EL SEGUNDO POWER REDEVELOPMENT PROJECT

Dry Cooling Amendment (00-AFC-14C)
Los Angeles County

STAFF REPORT

**JUNE 2008
(00-AFC-14C)**

PROJECT DESCRIPTION - SITE PLAN - FIGURE 2
 El Segundo Power Redevelopment Project - Amendment Petition For Dry Cooling

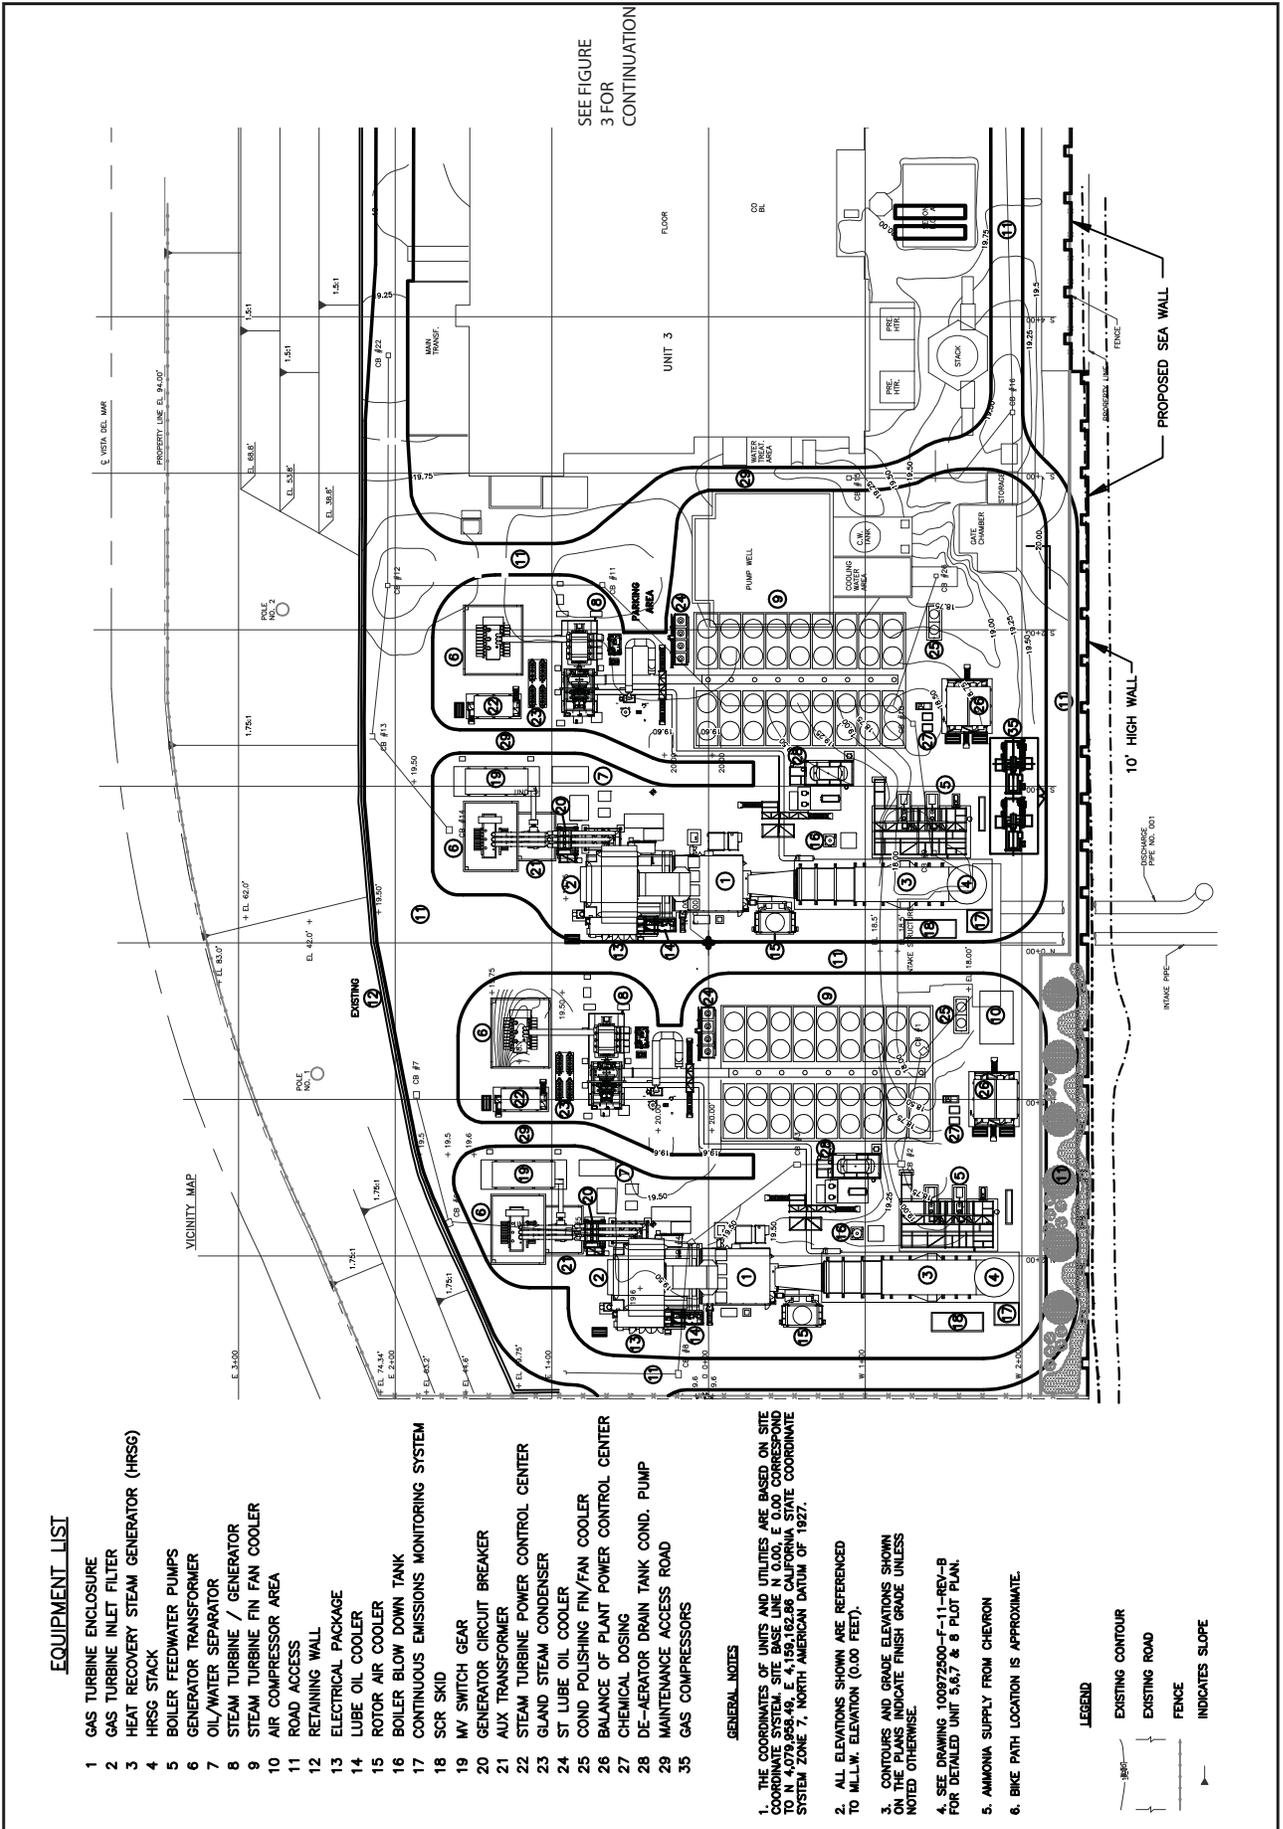
The site plan on **Project Description Figure 2** illustrates the location and size of the proposed generating facility presented in this amendment petition. For comparison, the overall layout of the new facility will be located in the same general area of the facility as previously permitted. The primary changes to the site plan include the following:

LAND USE - FIGURE 3

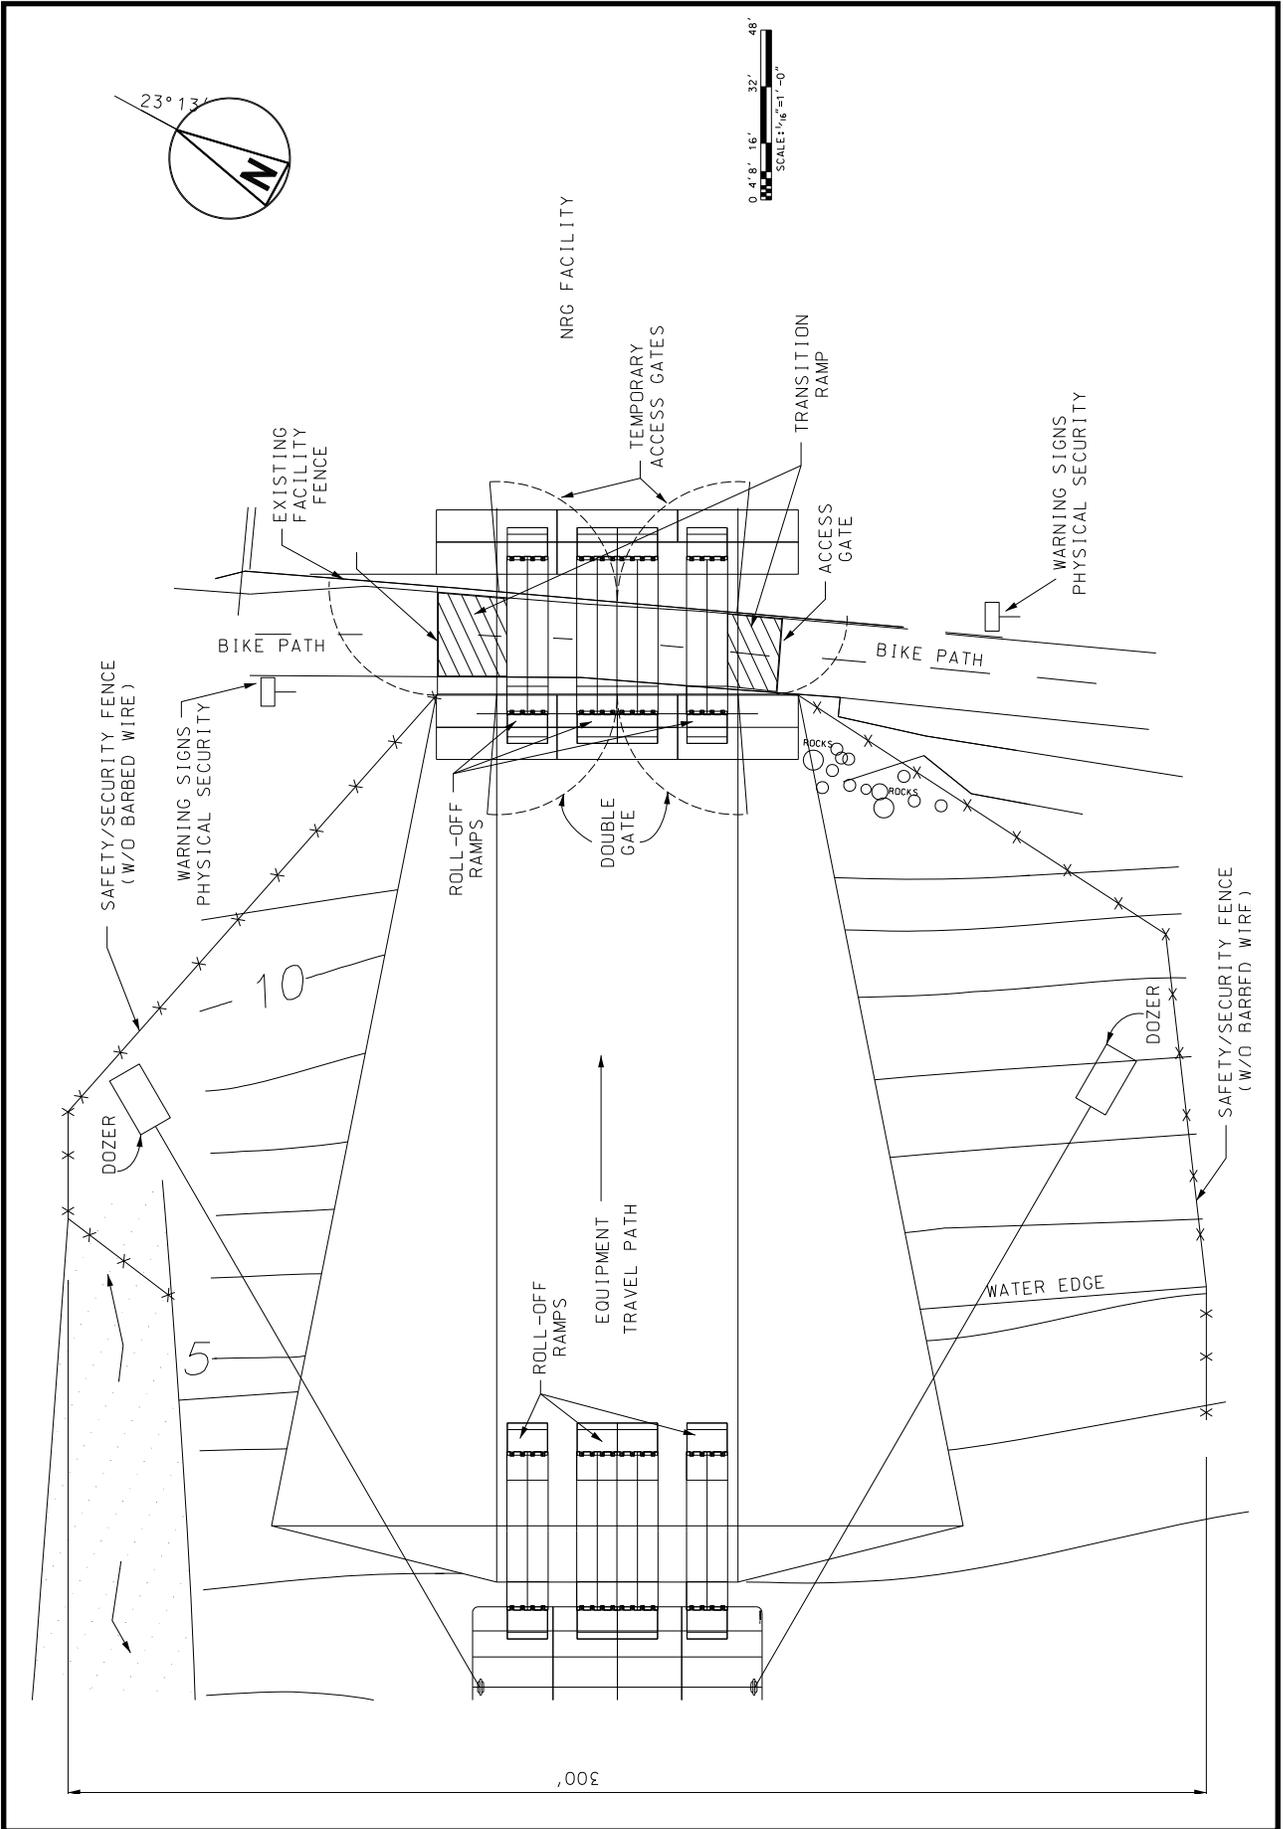
During the beach delivery phase, beach users would not be able to use an approximate 300-foot by 300-foot (2 acres) beach area west of the El Segundo Generating Station between Dockweiler State Beach and Manhattan Beach (**Land Use Figure 3** – Beach Area West of the El Segundo Generating Station). This beach area, owned by the project owner, is to be traversed by an approximate 250-foot long beach ramp made of geo-tech fiber, wood matting and sandbags with an access ramp extending over the bicycle trail into the El Segundo Generating Station. The access ramp would include closure gates across the bike path to prevent public access to the beach ramp during deliveries. Fencing for safety and security purposes would be installed around the beach delivery area (**Land Use Figure 4** – Conceptual Layout of Beach Delivery Area). Staff has recommended Condition of Certification **LAND-12** which provides for the restoration of the beach area after project construction is completed.

LAND USE - FIGURE 5

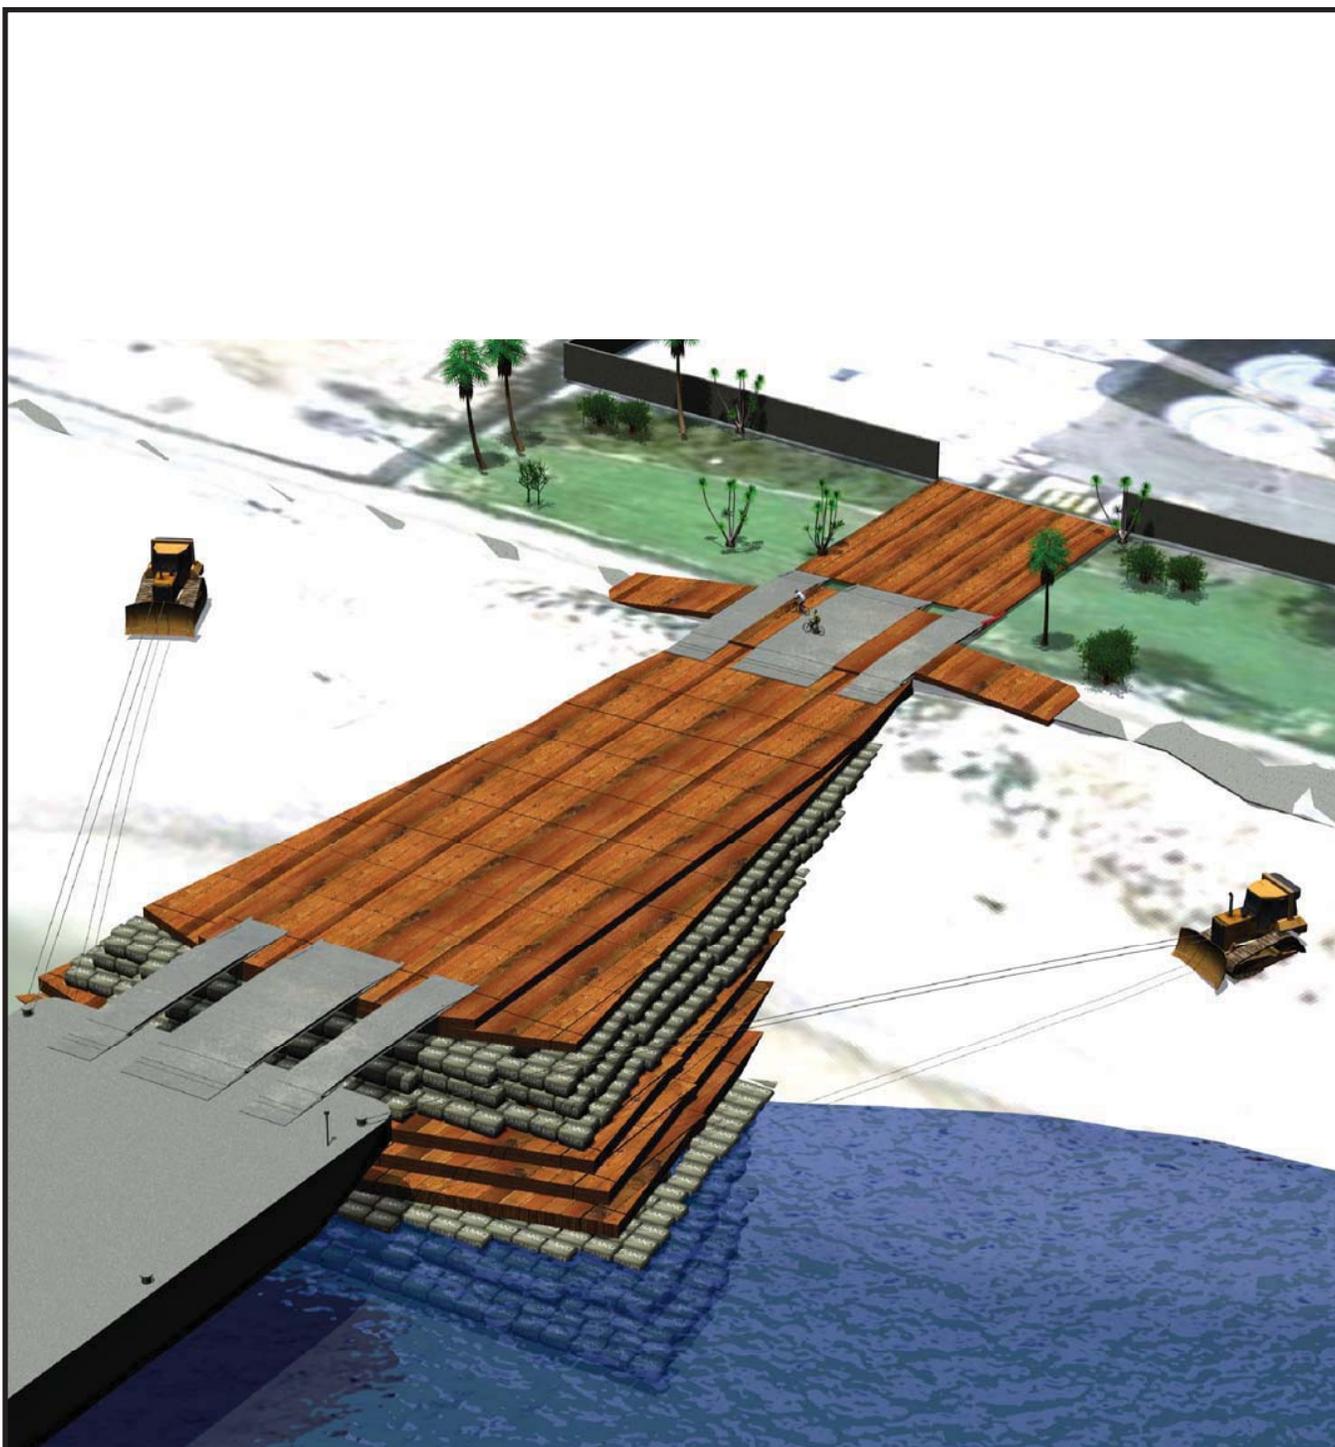
Public use of both Dockweiler State Beach and Manhattan Beach would remain available. The majority of public beach activity occurs to the north and south of the El Segundo Generating Station. During high tide, the narrow stretch of beach south of the beach delivery area is inundated; preventing beach users from walking along the shoreline (**Land Use Figure 5** -View of Beach Area Next to El Segundo Generating Station at High and Low Tide).

VISUAL RESOURCES - FIGURE 2
El Segundo Power Redevelopment Project - Final View KOP 1

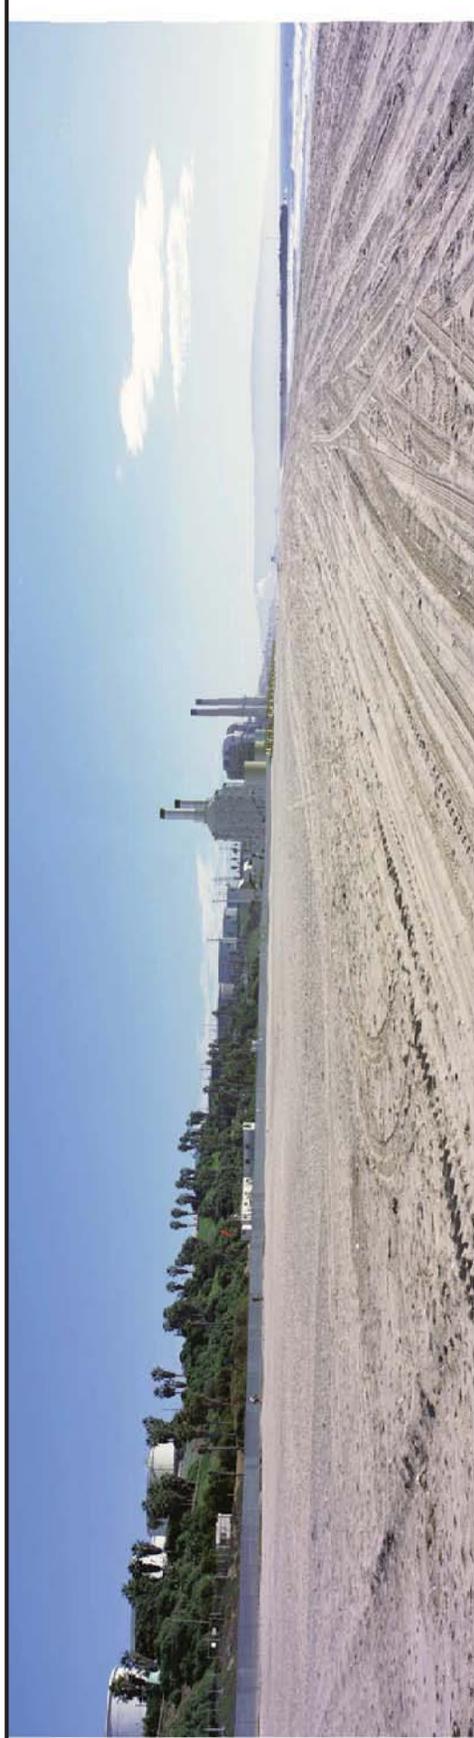
This KOP represents views to the south from the beach, bike path, and parking lots, which are located approximately 0.25 to 0.5 mile north of the project site. The visual quality at this KOP as seen in **VISUAL RESOURCES Figure 2** is generally high due to the open panoramic views of the Bay. Slopes east of the beach in the foreground of the Chevron marine loading facility are heavily landscaped.

As depicted in **VISUAL RESOURCES Figure 2**, the high degree of existing contrast between Units 1 and 2 and their setting would continue under the proposed amendment due to a comparable level of vertical line and form contrast between the proposed new units and the strong horizontal lines and open sky of the existing setting. The resulting

VISUAL RESOURCES - FIGURE 3
El Segundo Power Redevelopment Project - Final View KOP 2

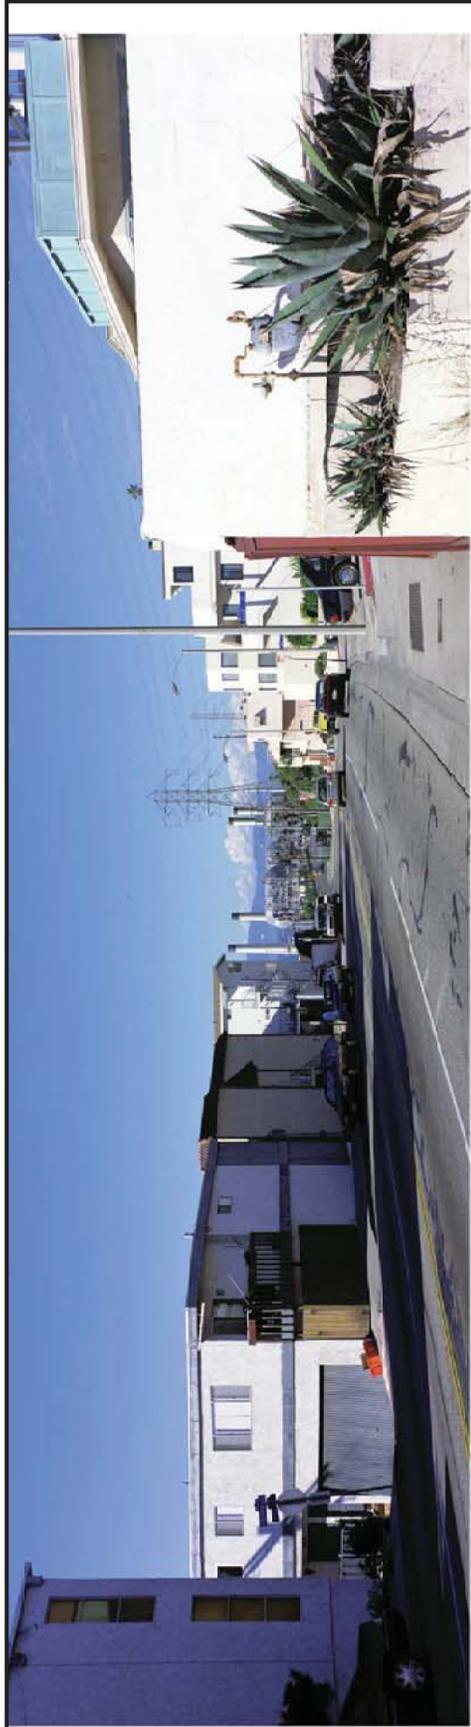
Visual quality from the area of this KOP, as seen in **VISUAL RESOURCES Figure 3**, is high due to panoramic Bay views in three directions. The ESPRP Units 1 and 2 power block is hidden behind Units 3 and 4, revealing only the visually subordinate exhaust stacks, which are closely aligned with the existing stacks.
